Serial No. 05-785B
ESP/JDH
Docket No. 52-008

DOMINION NUCLEAR NORTH ANNA, LLC
NORTH ANNA EARLY SITE PERMIT APPLICATION
RESPONSES TO DRAFT SAFETY EVALUATION REPORT OPEN ITEMS

Enclosure: Responses to Draft Safety Evaluation Report Open Items.

Figure 2.4-15 Groundwater Level Hydrographs

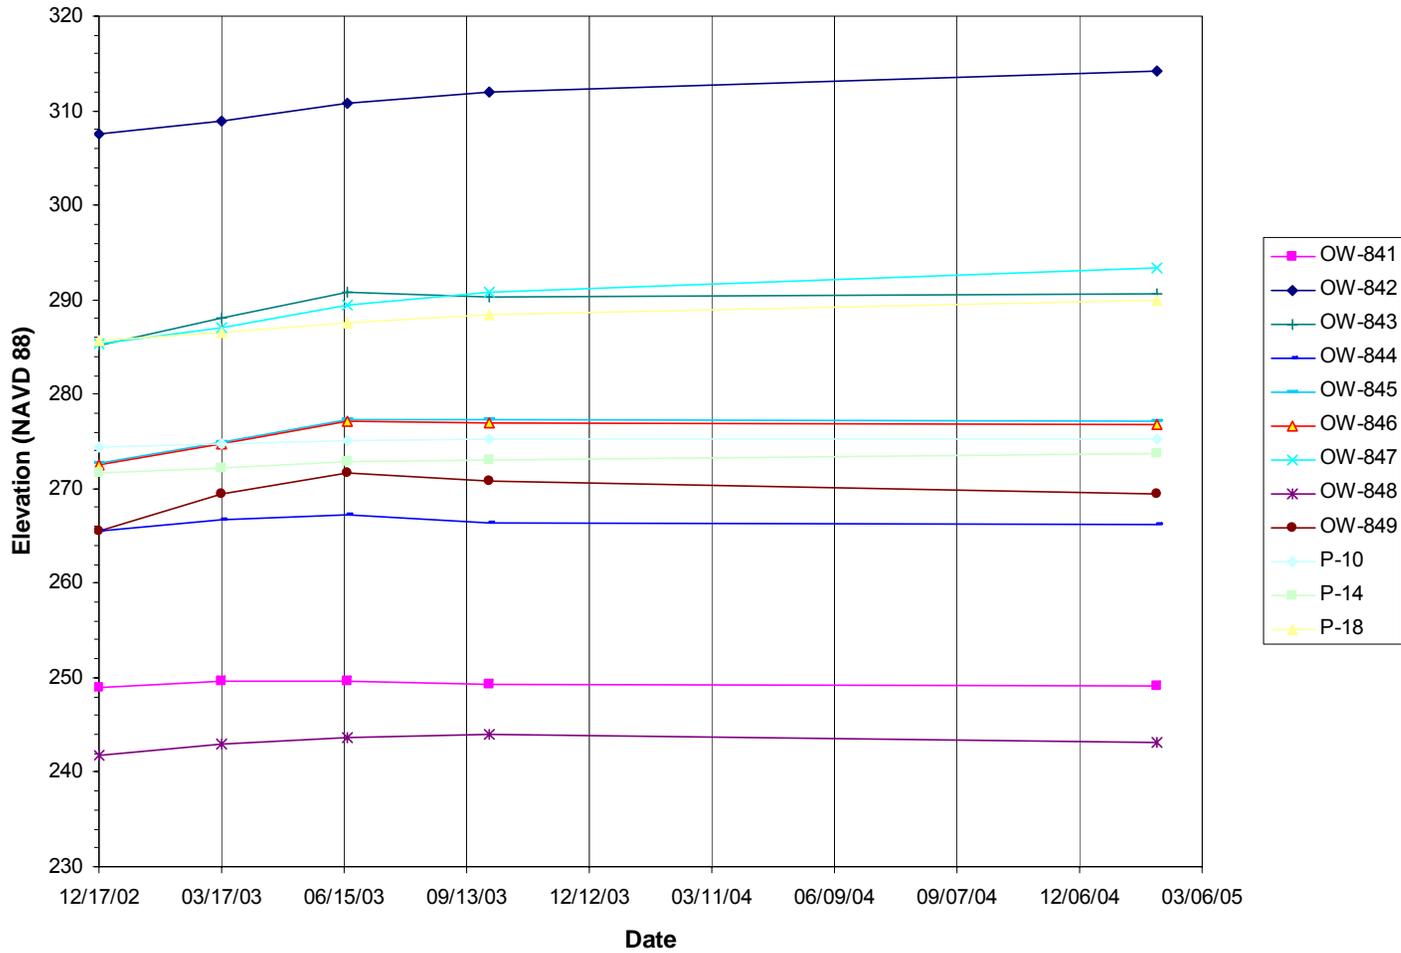
Observed increases in water levels in the new wells ranged from less than 0.3 m (1 ft) to more than 1 m (3 ft) over the period of December 17, 2002, through June 17, 2003. The applicant included previously existing wells monitored at the same time in the analysis. The observed variation in water levels in wells could be significant, but represented only a 6-month period. The staff evaluated additional information the applicant provided in response to RAI 2.4.12-1, but found that it needed additional data to determine whether the new ground water level measurements correlate with data from the long-term piezometers. Groundwater measurements should contain at least one full year of data to determine recent seasonal fluctuation in ground water levels at the ESP site. This is **Open Item 2.4-7**.

A supplementary round of groundwater level measurements were taken in the wells on February 1, 2005, about 1 year 4 months after the last quarterly groundwater level measurement and over 2 years after the drought had ended. Sufficient time has elapsed to allow the groundwater table to recover from the 2002 drought. SSAR Table 2.4-15 and SSAR Figure 2.4-15 have been updated to include the February 1, 2005 measurements (provided at the end of this response). In addition, Figures 1, 2, and 3 from the response to RAI 2.4.12-1 (Reference 1) have been updated with the additional groundwater level measurements (provided at the end of this response). The wells installed specifically for the ESP investigation generally show steady to slightly falling water levels between the current measurements and the previous measurements taken on September 29, 2003. Two wells (OW-842 and OW-847), however, show an increase in the groundwater level over this time period of 2.2 and 2.5 feet, respectively. Water levels in the previously existing site wells during this time period exhibit changes ranging from -0.2 to +1.7 ft with the majority of changes at 1 ft or less. Note that the water levels observed in the pre-existing piezometers P-10, P-14, and P-18 have been added to the revised SSAR Figure 2.4-15. For the period beginning December 17,

SSAR Table 2.4-15 and Figure 2.4-15 will be replaced with the revised versions shown on the next 3 pages.

GWL Contours 12-17-02

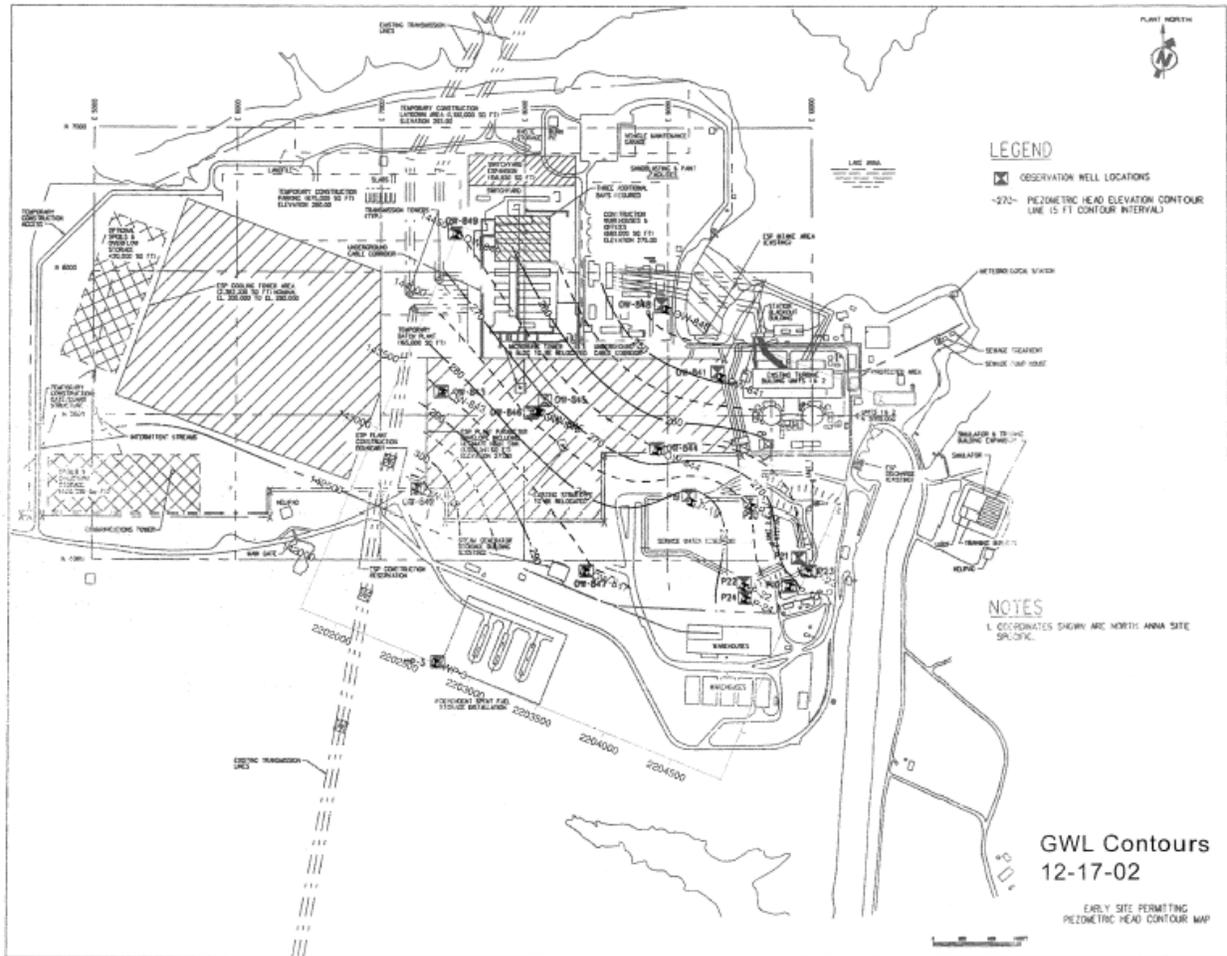
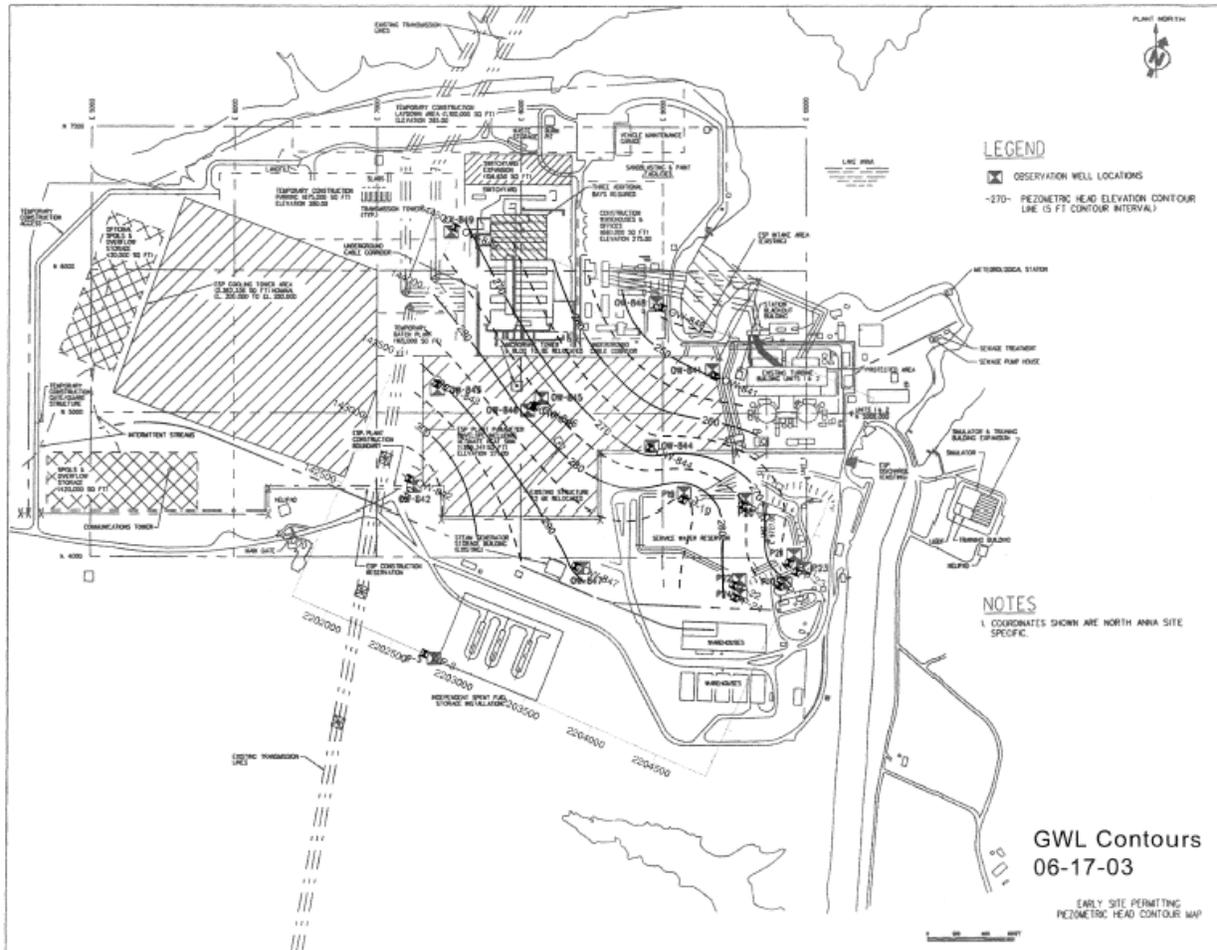
The applicant stated that the typical hydraulic gradient of ground water flow across the ESP site to Lake Anna and the WHTF is 0.03 m/m. The applicant based this estimate on only one piezometric head contour map constructed using ground water level observations from March 2003. The applicant stated that this hydraulic gradient is typical of the ESP site, despite seasonal and long-term variation in the ground water regime. However, the applicant should provide data to support this statement and to define the range of seasonal and long-term variation in hydraulic gradient from the ESP site into Lake Anna and the WHTF. This is **Open Item 2.4-10**. The staff intends to identify hydraulic gradient from the ESP site to Lake Anna and the WHTF as a site characteristic in any ESP that might be issued for this application.

Groundwater levels in the observations wells installed at the ESP site were monitored quarterly. A total of 4 rounds of quarterly measurements were obtained in the period beginning December 17, 2002 and ending September 29, 2003, and are provided in SSAR Table 2.4-15. Based on the groundwater levels recorded in the wells on March 17, 2003, a piezometric head contour map was prepared and included as SSAR Figure 2.4-16. Evaluation of the contour map indicated a horizontal hydraulic gradient of 0.028 ft/ft from the center of the ESP site footprint to Lake Anna.

A supplementary round of groundwater level measurements was performed on February 1, 2005 (see the response to DSER Open Item 2.4-7). The groundwater level elevations obtained from the last monitoring round, along with the 4 previous monitoring rounds, are provided on the updated version of SSAR Table 2.4-15 (at the end of the response to DSER Open Item 2.4-7).

Figure 1: NAPS Primary Evacuation Routes—Sector and Quadrant Boundaries

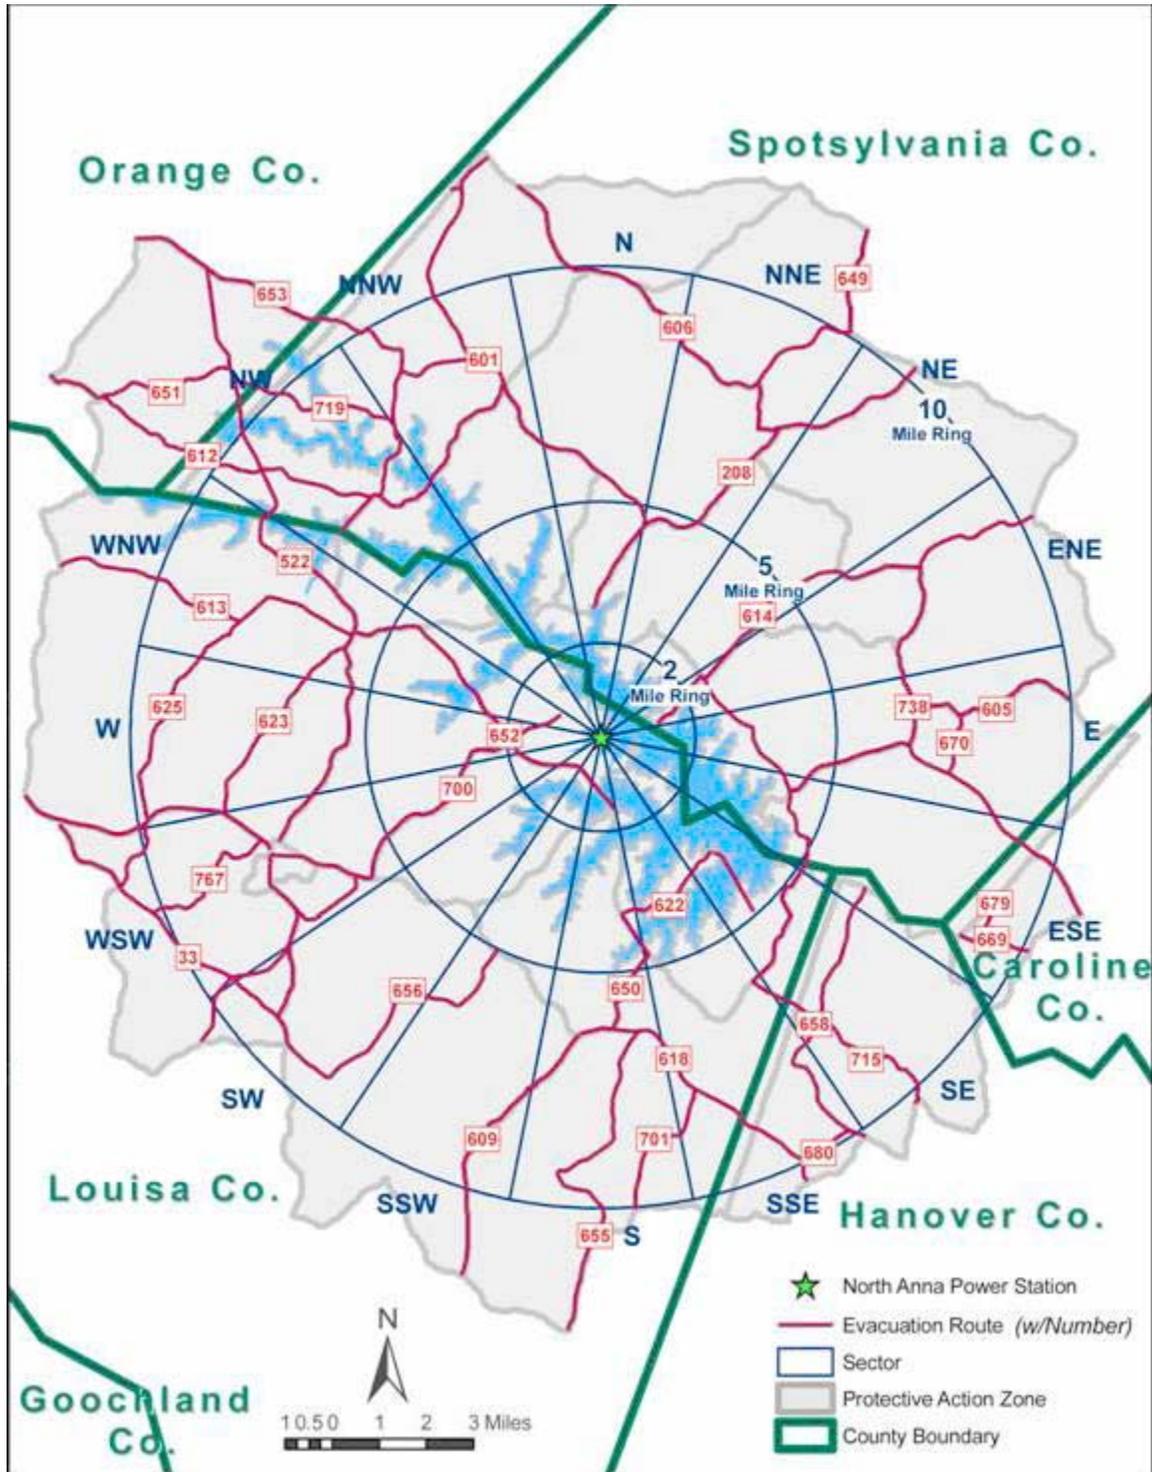
Please provide a figure (map) showing only those roads used as primary evacuation routes (e.g., Figure 3 of Appendix 4 to NUREG-0654/FEMA-REP-1), and also indicating the sector and quadrant boundaries.

Figure 1 (at end of this response) shows the primary evacuation routes, the sector and quadrant boundaries.
